Application for Modification of Minister's Approval (MP06-0175)
under Section 75w of the EP&A Act 1979 (MOD 2)

Site 8a Murray Rose Drive, Sydney Olympic Park, Homebush
Prepared for Watpac Developments Pty Ltd
January 2009

Figure 2.1: Proposed loading areas for Site 8a

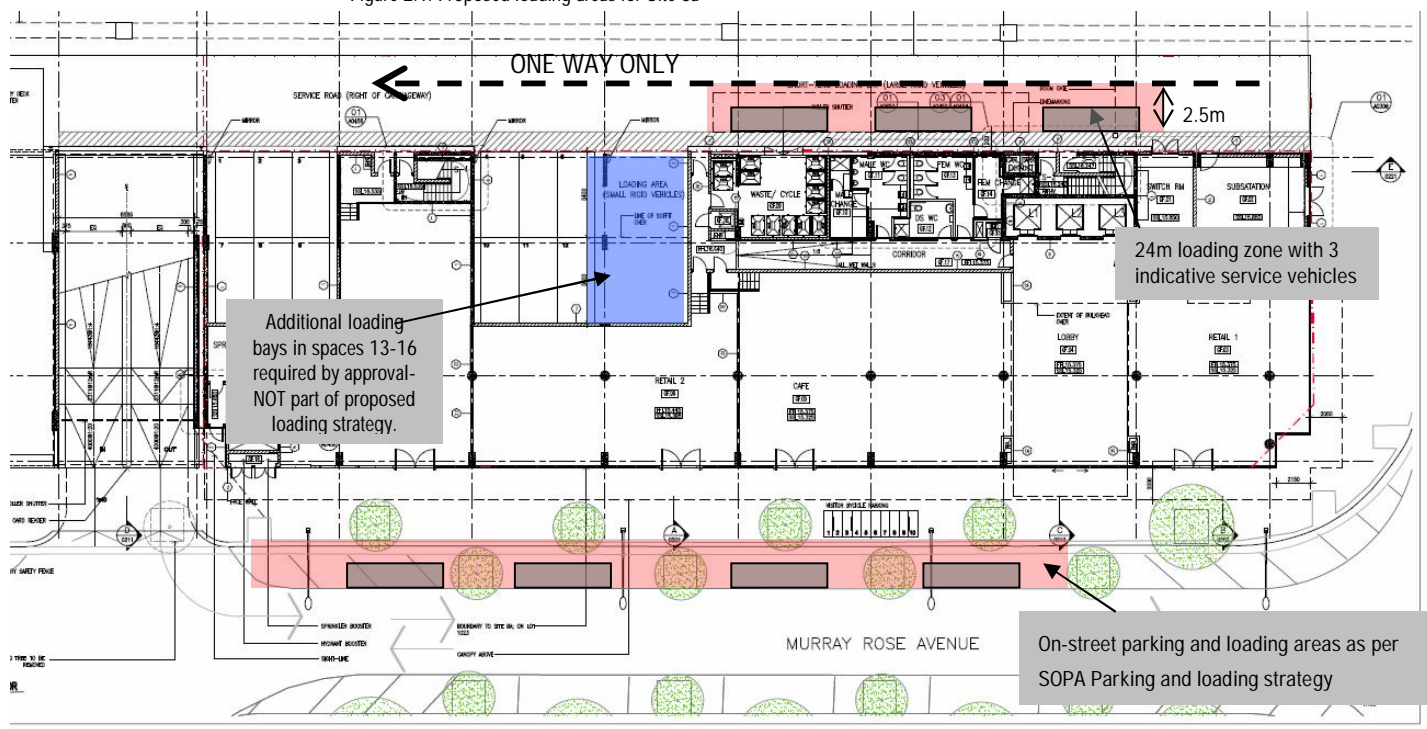
An approved short term loading bay is located along the service lane at the rear of the building. This area will be indicated by clear signage and line marking. The loading bay can accommodate three service vehicles or three Small Rigid Vehicles. As part of this Modification, it is requested that the short term loading bay is increased from 20m to 24m long to provide ample space for loading vehicles that can be accommodated without obstructing entry and egress into the build. The extended loading bay was advised by the traffic consultant.

Condition B1(1)(b) requires that 4 at-grade car parking spaces (numbered 13-16) be converted for additional loading areas (shown in blue in Figure 2.1). The addition of up to 2 loading bays available in car spaces 13-16 will increase the number of loading bays on site up to 5, plus those on Murray Rose Avenue provided as per SOPAs on street parking scheme, which is clearly in excess of the Auburn DCP requirements and excessive for a development of this size and nature.

It is therefore submitted that the proposed loading scheme of the 24m loading bay and on street parking, as per SOPAs on street parking scheme, is sufficient to meet the loading needs of Site 8a and will provide effective and safe loading areas. As such it is respectfully submitted that Condition B1(1)(b) is deleted and Condition 13 amended to remove the requirements for loading bays 13-16 to be used for loading purposes.

Figure 2.2: Proposed roof plan for Site 8a

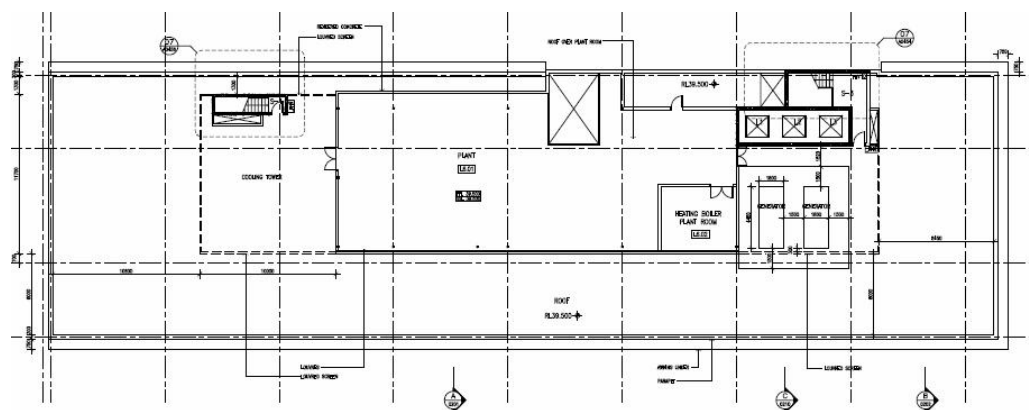
This amendment seeks to install the generator during the construction phase and also provide screens to the generator area to minimise the visual impact of the generator area. Screens are also required to meet safety regulations.

The generator area will be smaller than that indicated on the approved plans and sit directly behind the elevator shafts and only be visible from the eastern and southern facades. The setback to the eastern façade will be 8.45m which is greater than the indicative 5m setback for the future generator area showed on the approved plans. The setback to the southern façade will be 6m and will align the southern setback of the plant area. It is therefore considered that the installation of generator screens will have minimum impact on the visual appearance of the Site 8a building.

Figure 2.3: Northern Façade to Site 8a

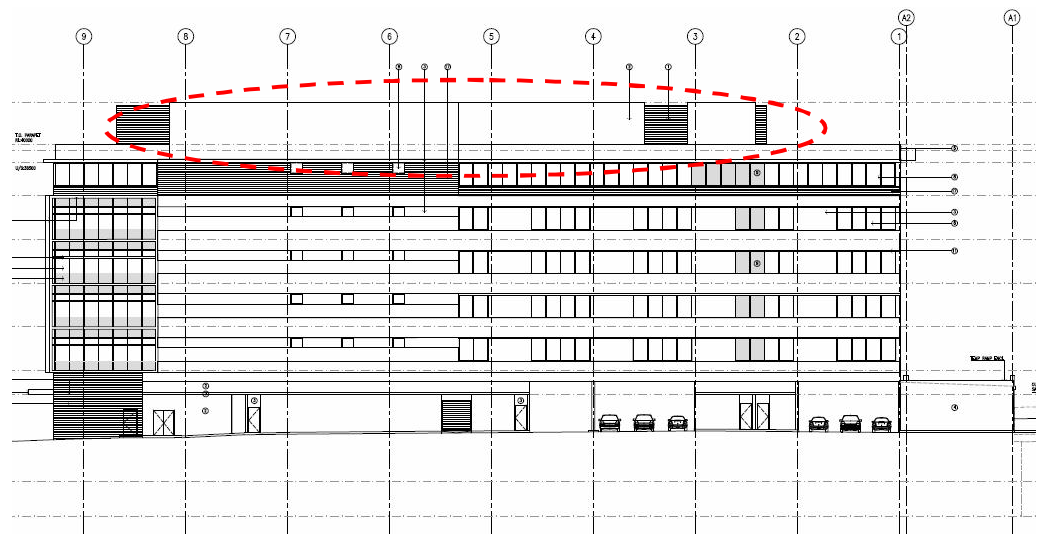
To accommodate the required plant areas including a second set of emergency access stairs and egress required by BCA, a portion of the northern wall of the plant area will be realigned with the parapet. It is noted that the issue of the second stairs was part of the Preferred Project Report (HASSELL 2008) issued to the Department of Planning during the DA process).

A portion of the outer plant wall has been moved to the parapet line along the southern façade to be integrated into the overall design of the building, and the strong vertical feature of the northern façade. This façade is not visible from the Murray Rose Avenue frontage and therefore will not impact vistas within the Sydney Olympic Park Town Centre.

Figure 2: Building 8A Loading Zone

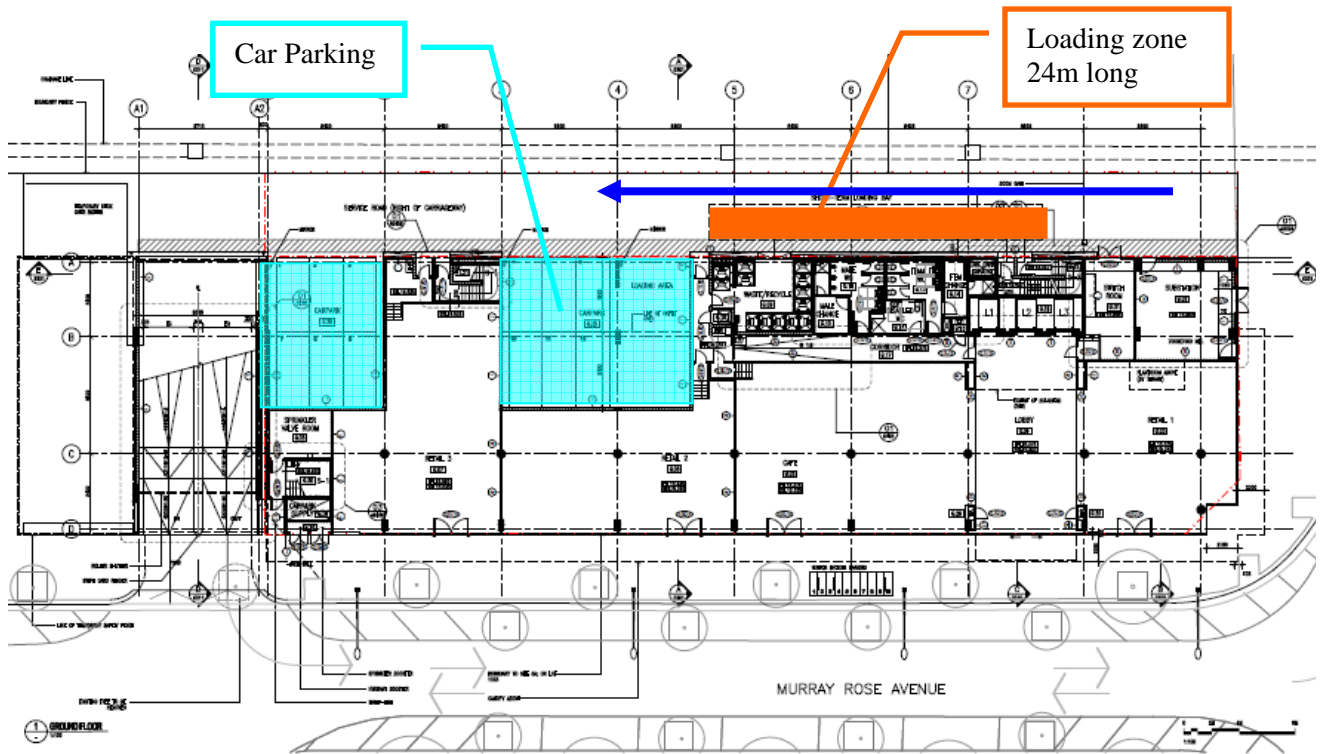
A 24 m long loading zone is proposed in the service road as shown in Figure 2. Given that this loading zone relates directly to the servicing area for the building it would be suitable to allocate loading to the building in this zone for 2 to 3 trucks/vans with other loading being able to occur on-street in Murray Rose Avenue (couriers/ van deliveries/ private shop owner vehicles, etc.). The laneway loading zone is clear of the car spaces and takes note of fire egress routes. It is proposed to install a boom gate at the lane entry with swipe card access for tenant parking and intercom communication to each business for truck entry.
